CITY OF PORTLAND, MAINE
DEPARTMENT OF BUILDING INSPECTION

CITY OF PORTLAND
DEPARTMENT OF PUBLIC WORKS
DEMOLITION OF BUILDINGS

APPLICATION FOR AMENDMENT TO PERMIT

Memorandum from Department of Building Inspection, Portland, Maine
229-735 Danforth St.--Installation of gasoline storage tanks for and by
Community Oil Co.

227 to 295 Danforth Street
 Portland, Maine.
 Scale 20' = 1" DATE 19...

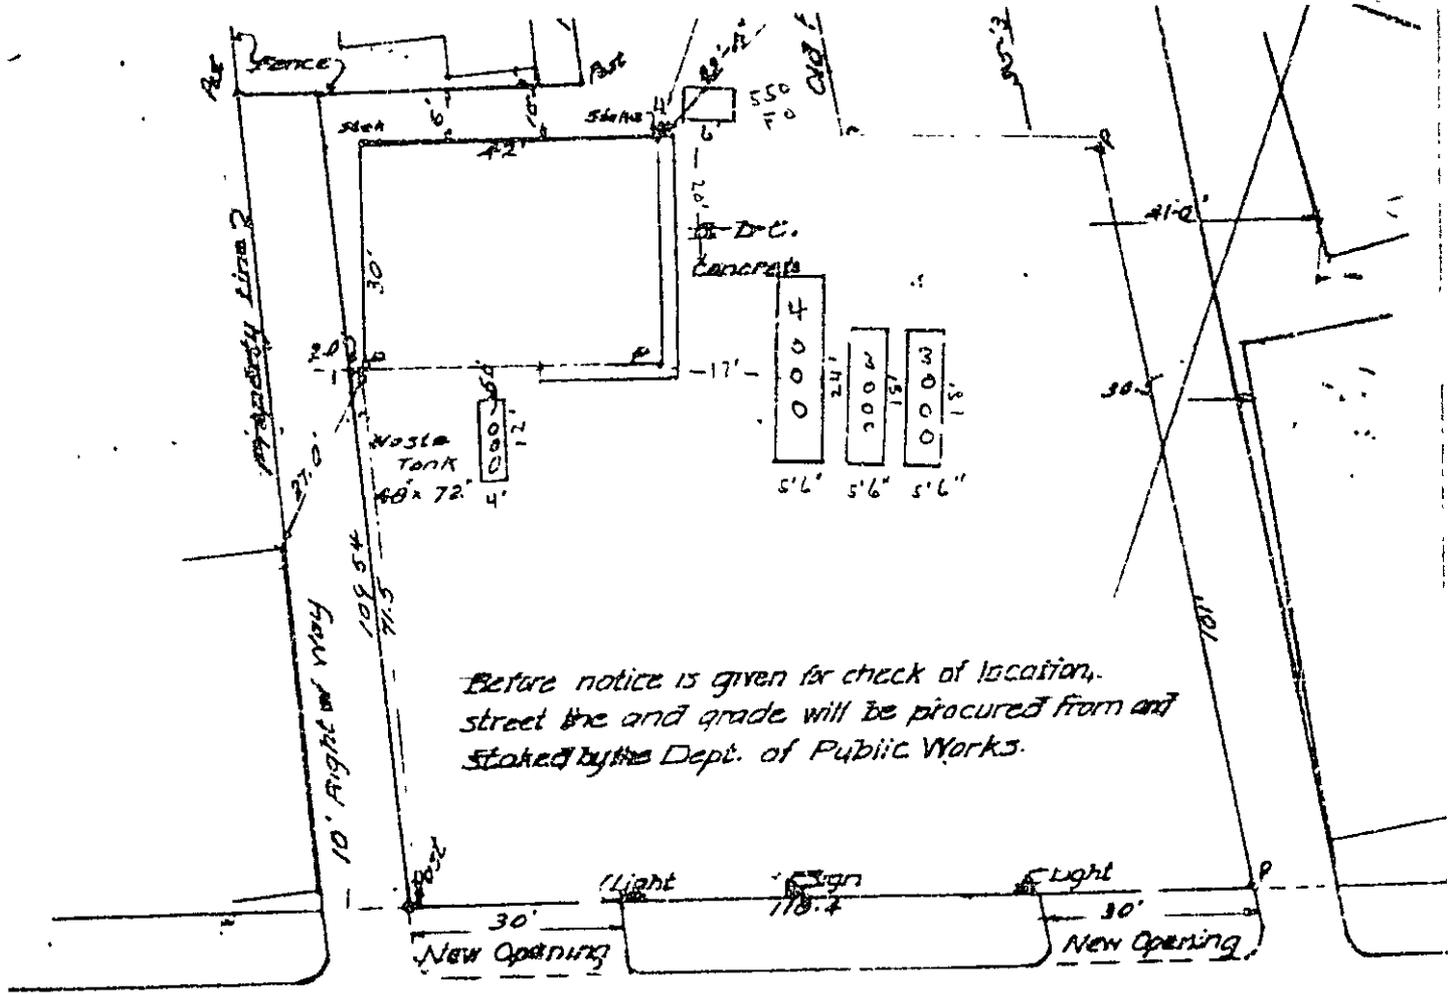
To change location of tanks as per plan filed today. To change the 1-5000 gallon tank to 2-3000 gallon tanks and to install 1-550 gallon fuel oil tank.
